September 14, 1984

Millstone Nuclear Power Station, Unit No. 2  
Followup Actions to Amendment No. 90  
to Operating License No. DPR-65

Additional Information Supporting  
the Cycle 6 Reload Safety Analyses

Figure 1

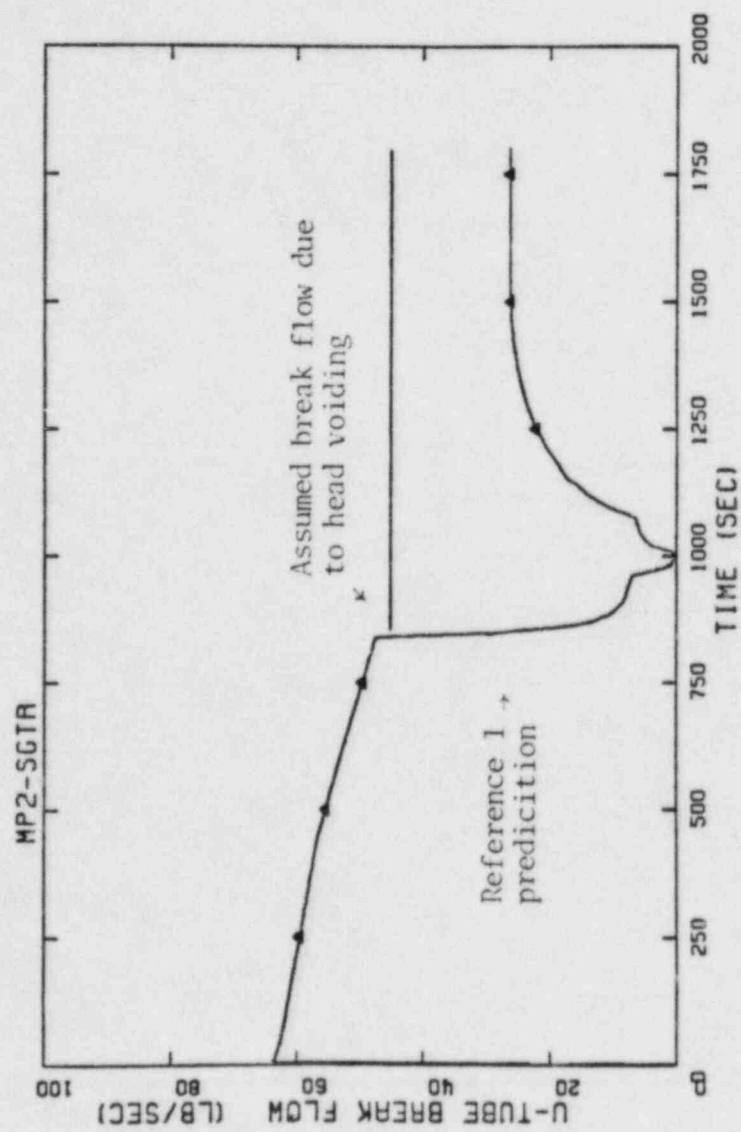
NNECO committed to provide the Staff the results of an evaluation of reactor vessel upper head voiding on the steam generator tube rupture accident assuming a 12% safety valve blowdown. NNECO had previously provided the results of the tube rupture analysis considering upper head voiding in Reference (3); however this evaluation assumed the steam generator safety valves reseal at their opening pressures. The impact of additional safety valve blowdown was addressed in Reference (4). This calculation provides the results considering the combined effects of potential upper head voiding and the worst case safety valve blowdown (12%).

Head voiding would cause a less rapid primary system depressurization and result in an increase in primary-to-secondary system break flow following reactor trip. The slower depressurization is caused by flashing of the hot water contained in the relatively stagnant head region. The calculation was performed with RETRAN02 MOD002. Although this calculation does not specifically represent the upper head in RETRAN, it conservatively bounds the possible increase in flow from the primary system into the steam generator that might be caused by upper head voiding. The maximum post-trip pressure drop between the primary and secondary systems corresponds to the saturation pressure of the upper head region (1600 psia) minus the steam generator safety valve closing pressure (870 psia assuming 12% blowdown). The increased break flow based on these conditions was modeled in RETRAN as a fill junction with a constant flow rate for the time following reactor trip. Since the increased break flow is modeled as a fill junction, the primary system response in this evaluation is essentially the same as that in Reference (4). Prior to reactor trip, the break flow is calculated identically to the Reference (4) calculation. A comparison between the break flow calculated in Reference (4) and this evaluation is shown in Figure 1.

This analysis predicts that the increase in steam flow to the environment caused by head voiding is bounded by 1.2 percent compared to the worst-case analysis presented in Reference (4).

The radiological dose for the worst case presented in Reference (4) is less than 1 Rem. The increase in offsite dose caused by an increase in steam release to the atmosphere of 1.2 percent is small and well within the 10CFR100 limits. It is therefore concluded that the effects of head voiding on the analyzed consequences of the Millstone Unit No. 2 steam generator tube rupture are negligible.
